Michael Collins Architect LLP

158 Cambridge Road

Job No.
242 South Elevation
as Proposed

Stage: Stage 3
Status: NMA

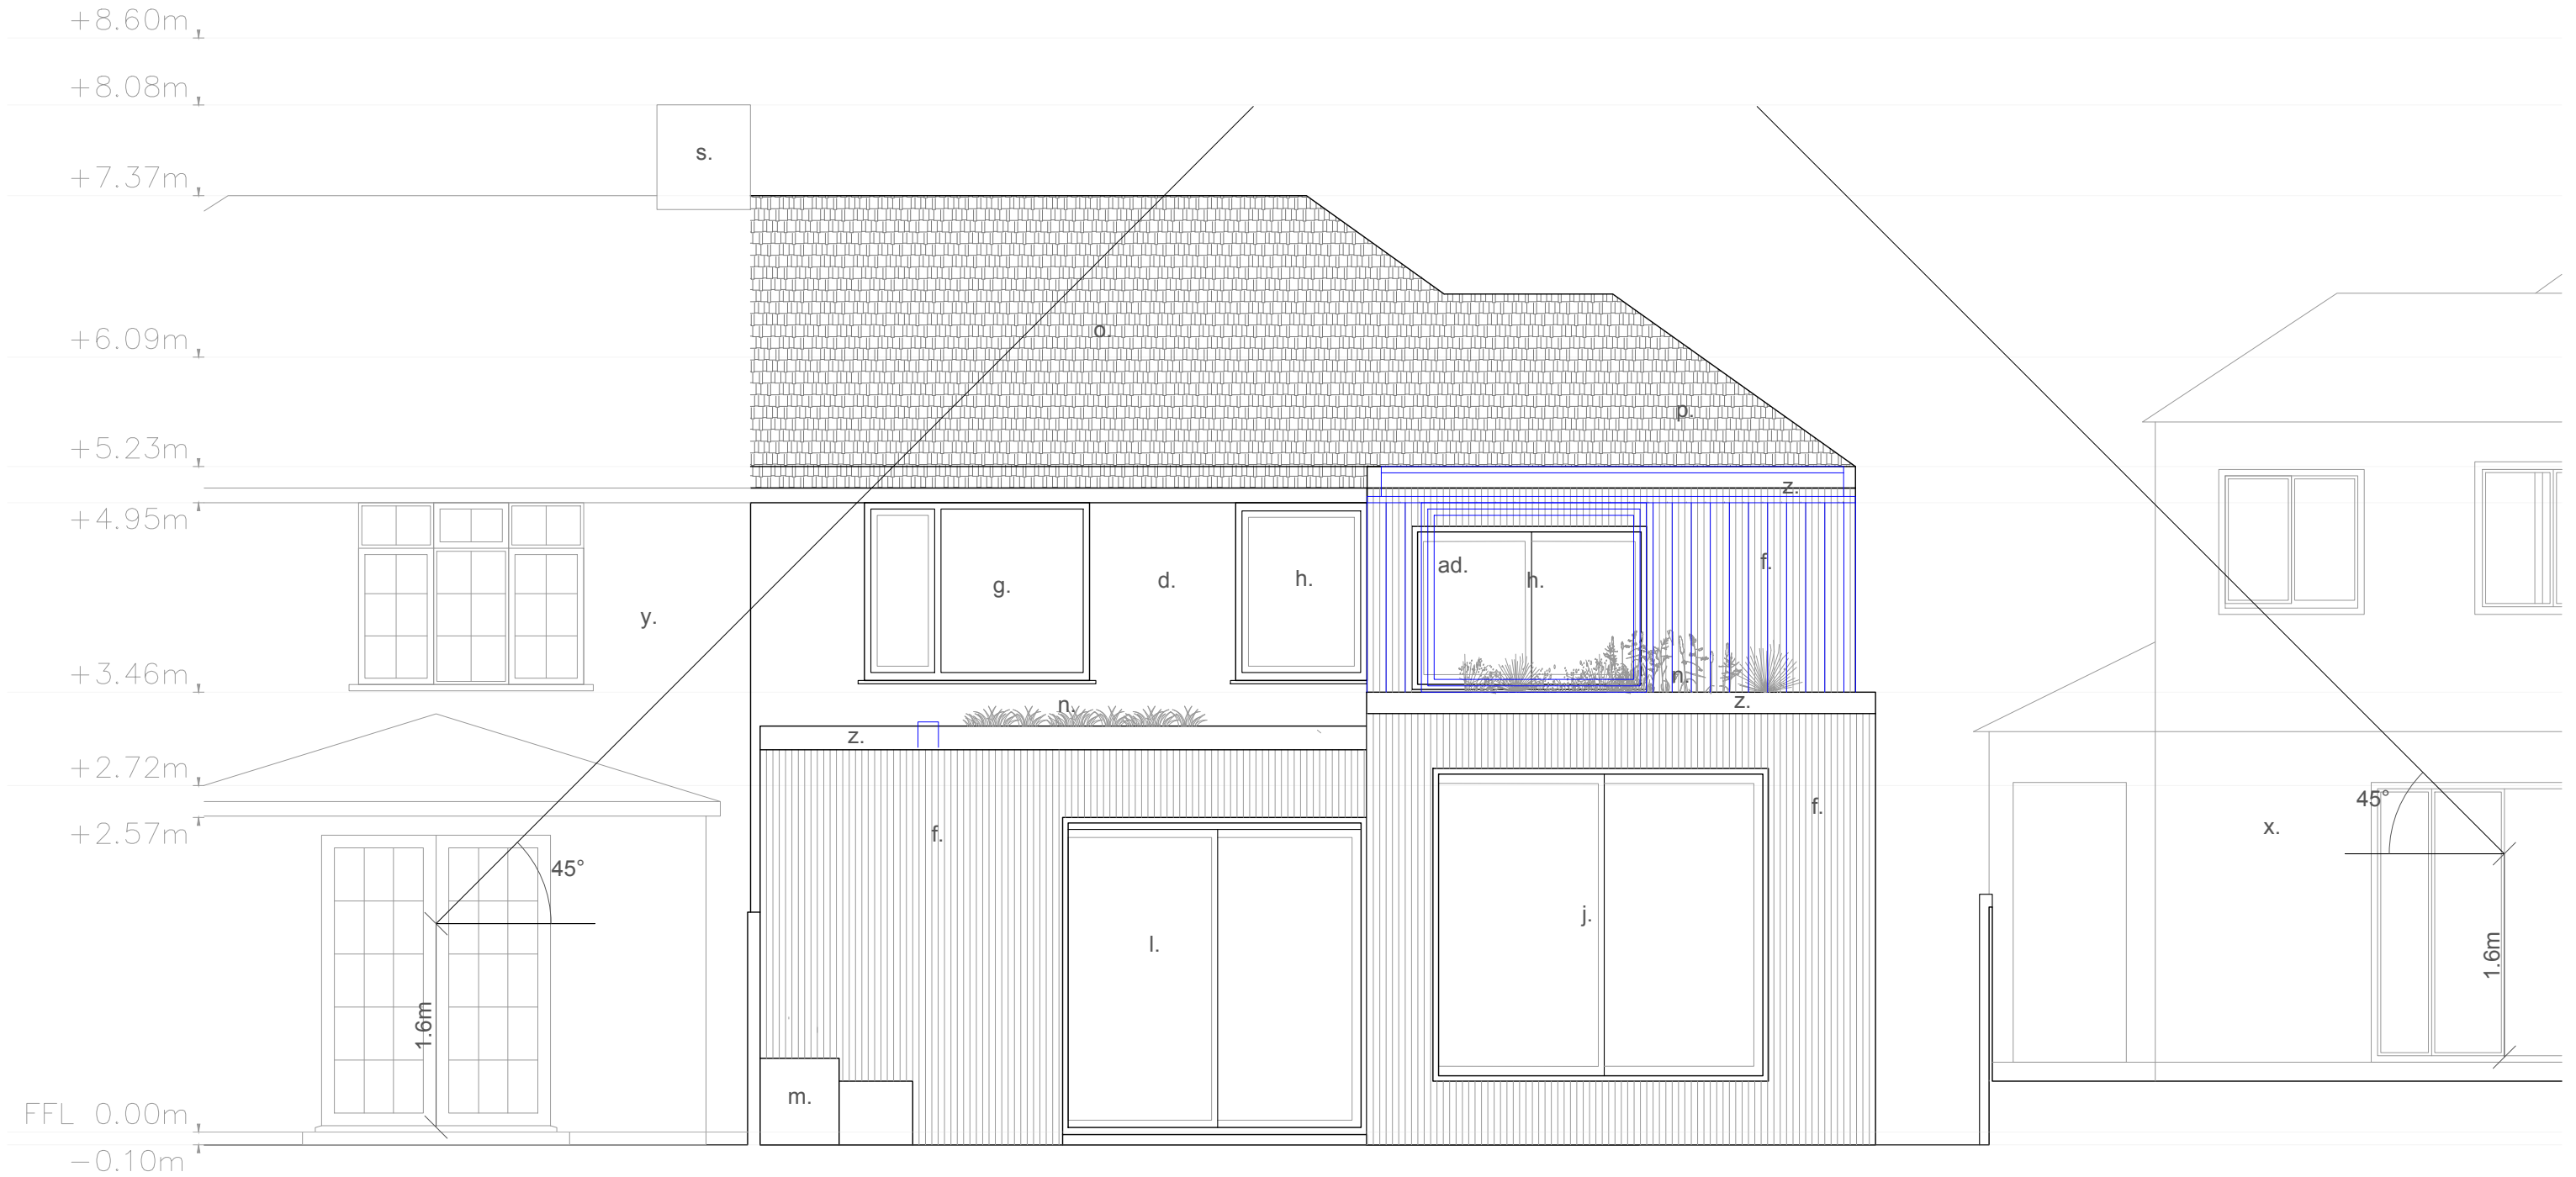
| f. Proposed 47mm Siberian Larch Cladding with weathered stain also proposed at first floor level in place of aluminium standing seam cladding and within set-in bike store wall in place of render | m. Proposed Concrete Planter and Integrated Concrete Bench | w. Proposed Espalier Wire and Post Climber Support |
